OIL CONSERVATION DIVISION

Case 5,899

As requested by Mr. Steve Reed's letter of April 16, 1981, and as authorized by Commission Order No. R-5516, Parabo is authorized to add an additional evaporation pit (Pit 6) at their facility east of Eunice, New Mexico.

Re: Parabo expansion

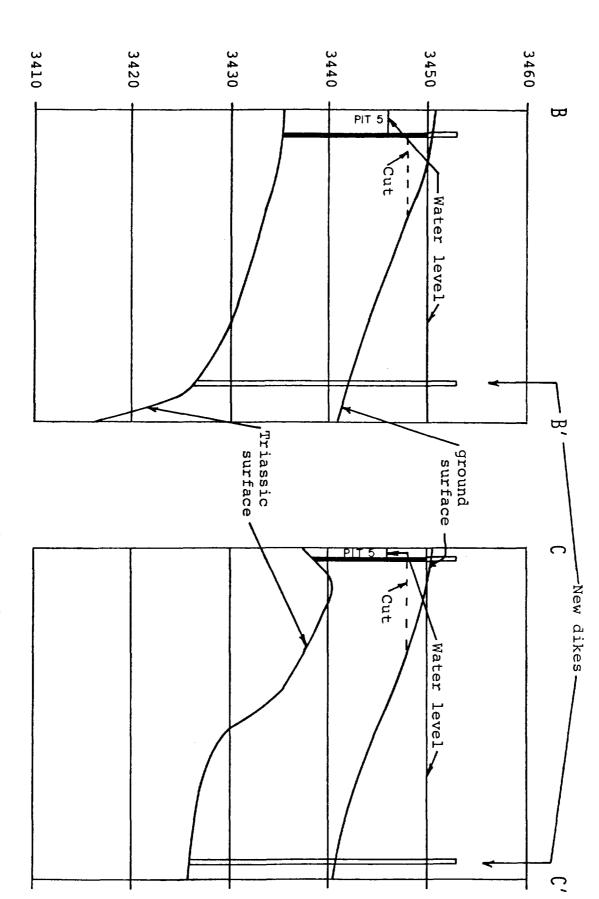
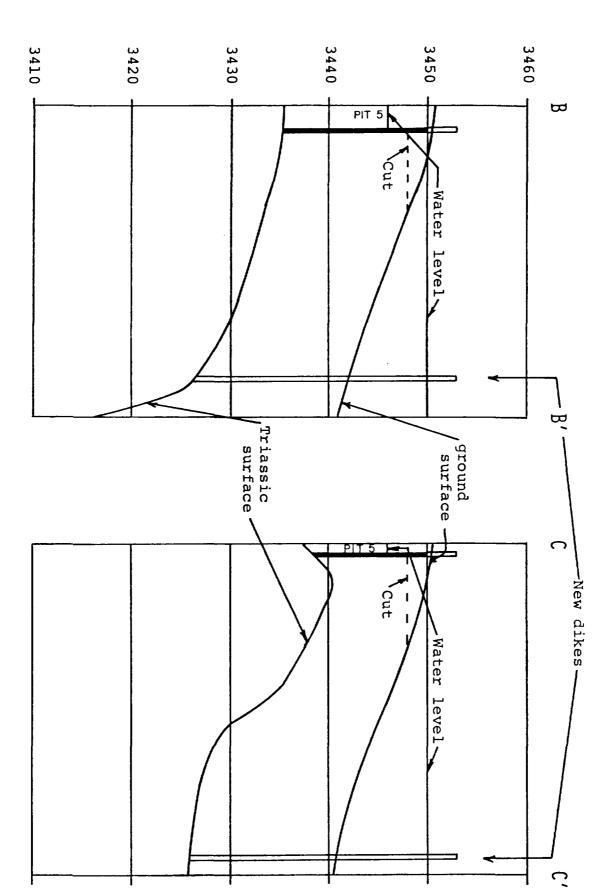
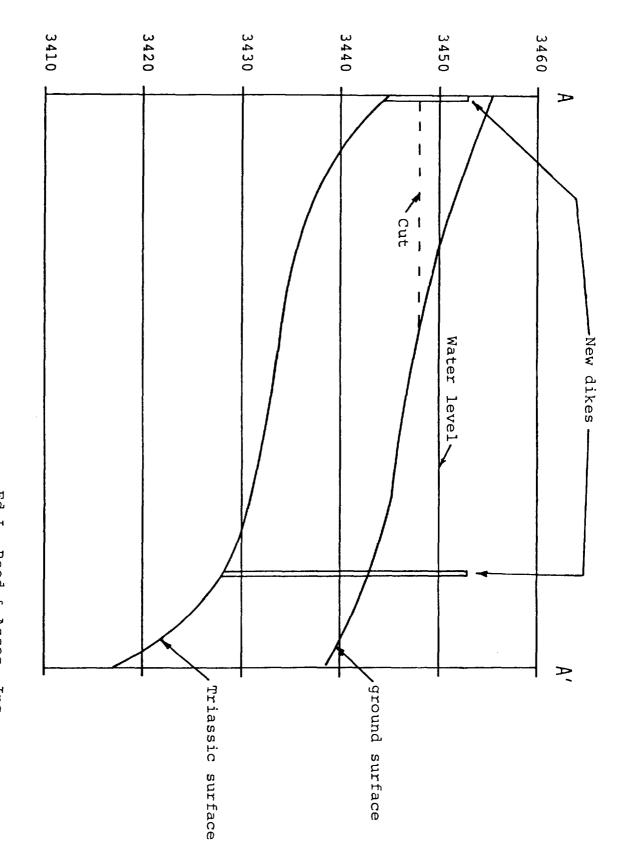
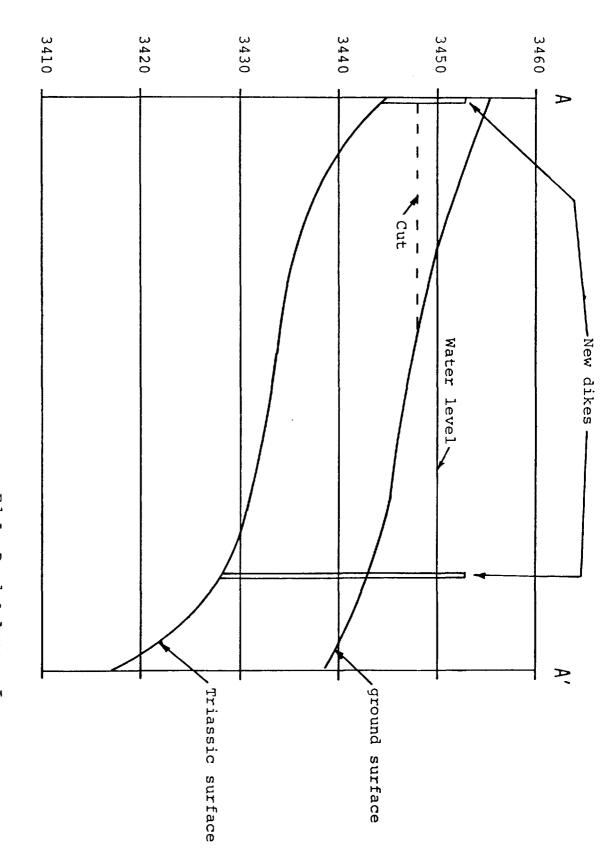
As can be seen from the cross-sections, the southern side of the core trench/dike is as high as 27 feet. With a 3-foot freeboard the maximum height impounding water is 24 feet. Over half of this structure would be completed below ground level with a maximum exposed dike of 12 feet, three feet of which are for freeboard. Thus, even though the core trench/dike is quite high on the south side, there should be no problems with its structural integrity.

Due to the height of the proposed structure, I have calculated the time which one could expect salt water to leak through the base of the core trench at its deepest point where the pressures are the highest. The velocity of movement through the structure is calculated using the formula as follows.

Therefore, a 15-foot thick dike would not begin to leak at its lowest point (24 feet below the water level) until there had been continual impoundment for 6500 days or almost 18 years. I consider the 18 years to be a minimum time period and thus consider the structure capable of adequate impoundment. Assuming the structure did begin to leak after 18 years, the total leakage along the 1100 foot long south side of the core trench would be 0.4 gallons per day along the basal one foot of structure.
